**Site Inspection of Potential Perfluorinated Compound Release Areas  
Field Variance Memorandum #5 – Field Conditions Preventing Collection of Groundwater  
and Soil Samples**

Date: 26 June 2018

Subject: Field Conditions Preventing Collection of Groundwater Sample in Cluster E and Soil Samples in Cluster C, Former Williams Air Force Base Mesa, Arizona

**Figure 6**  
**AFFF Investigative Cluster E:**  
**Areas 14 and 15**  
**Proposed Sample Locations**

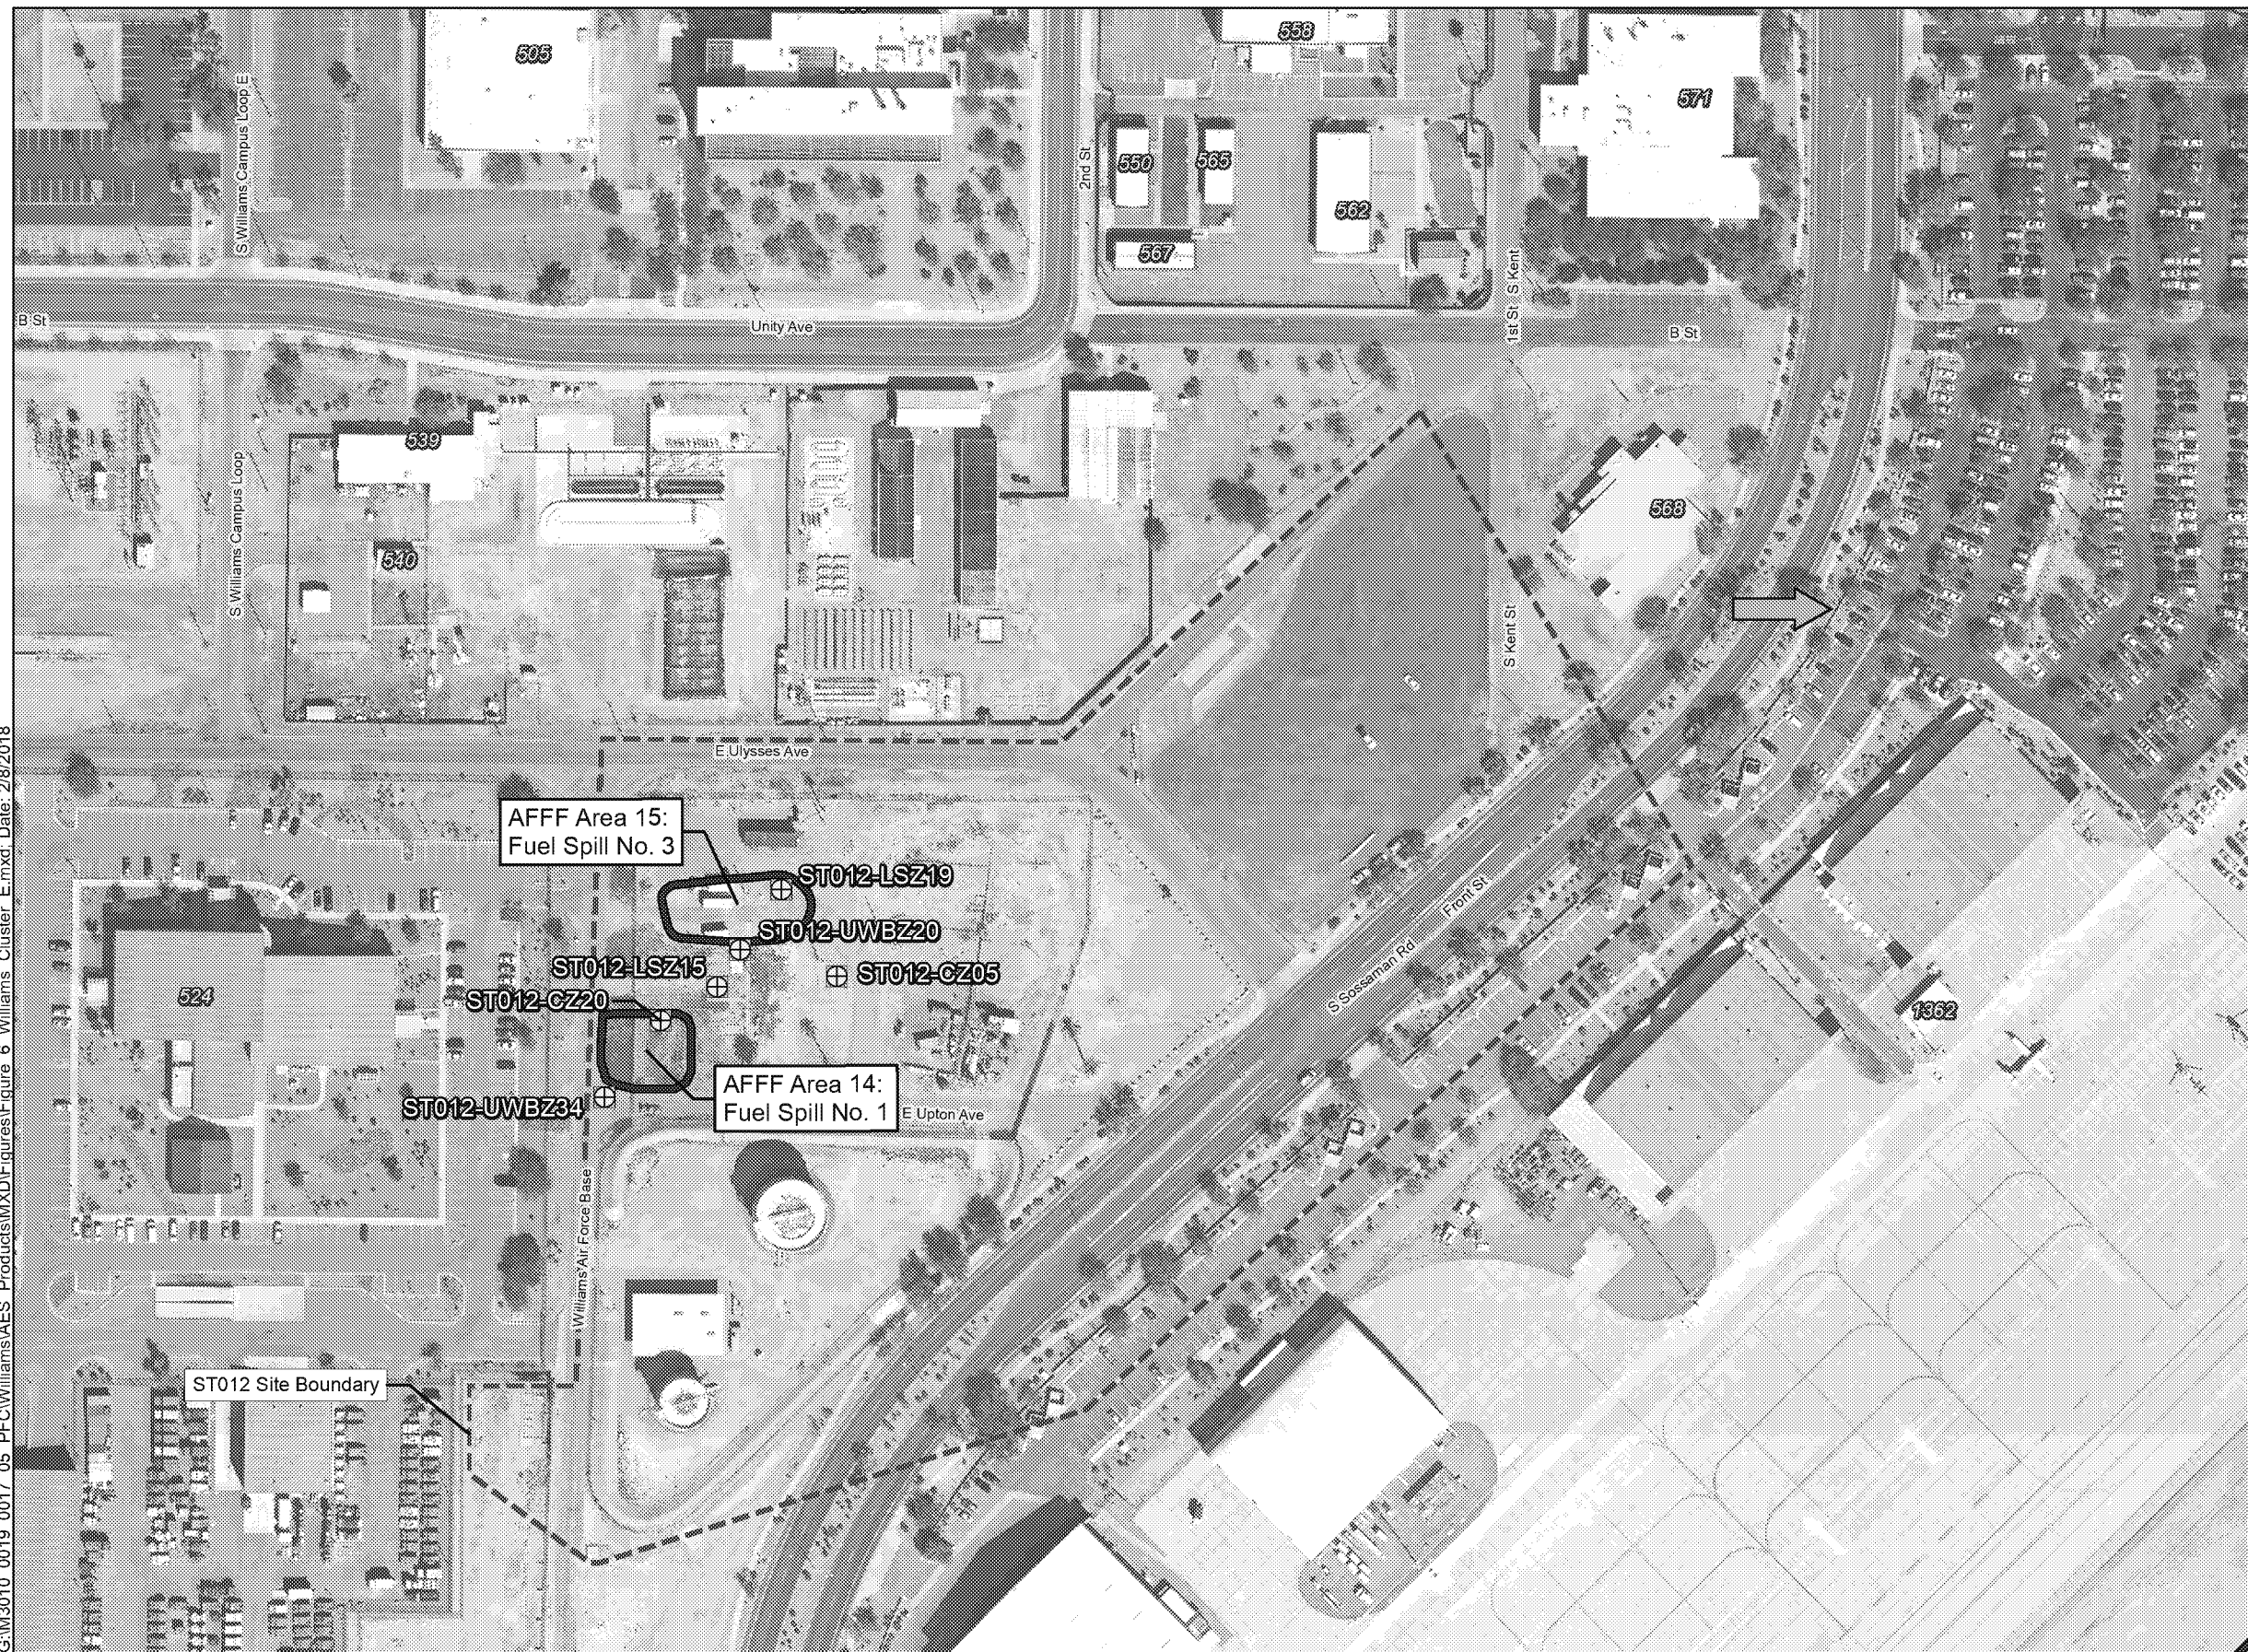
For Cluster E, six existing groundwater wells were proposed for sampling using Hydrasleeves, which were deployed on March 8, 2018. Hydrasleeves were retrieved and groundwater successfully collected at five of the six locations on March 23, 2018. However, a groundwater sample could not be collected at ST012-LSZ19 (Figure 6) because the Hydrasleeve failed. At this location, a groundwater temperature of 188°F was measured at the time of sampling, which exceeds the limit of the Hydrasleeve. It was determined that the water temperature was still elevated from the ST012 Steam Enhanced Extraction treatment. The elevated temperature also exceeds the limit of equipment that could be used for traditional groundwater sampling (i.e., pumps, tubing, and bailers). Therefore, a groundwater sample cannot be collected at this location.

Although field conditions prevented a groundwater sample from being collected in Cluster E and two soil samples from being collected in Cluster C, sufficient data was successfully obtained from the remaining proposed locations to allow the project objectives to be met.
